Job name: Land West of Shoreham Road, Small Dole

Note No: BR31013-JNP-XX-XX-RP-C-1002

Subject: DC/25/1019 – LLFA comments response

Topographical
Survey - Sheet 2 of 4

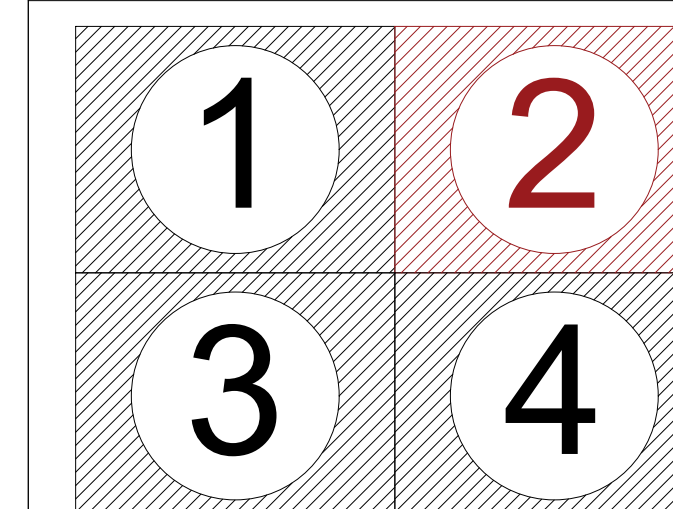
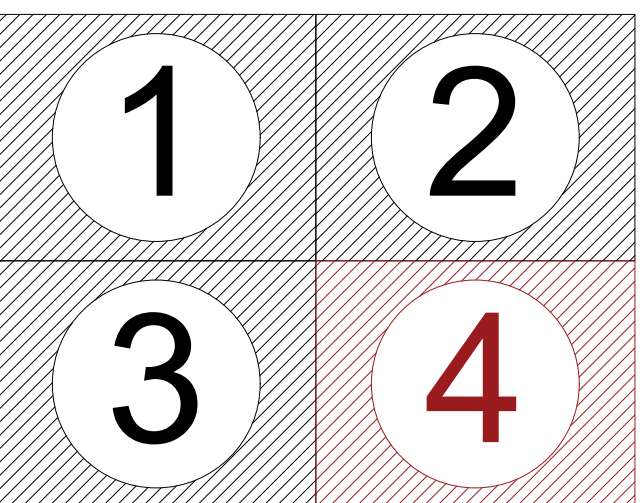
1). “The topographic survey provided is not clear for the watercourse along the southern boundary of the site, which it is proposed to discharge to (see below example). We require a more comprehensive topographic survey with top of bank and bed levels. Please ensure any existing and proposed structures are clearly marked with invert levels and pipe diameters. In particular, this should include the culvert(s) immediately upstream to the East and the proposed outfall headwall. This will enable us to ensure a gravity connection from the site is feasible and to assess flood risk more accurately.”

- 1.4 A new topographical survey has been procured to provide the additional detailed requested by the LLFA. See attached appendix. The topographical survey now supplies the additional features requested and we believe this will allow the LLFA to undertake their assessment.
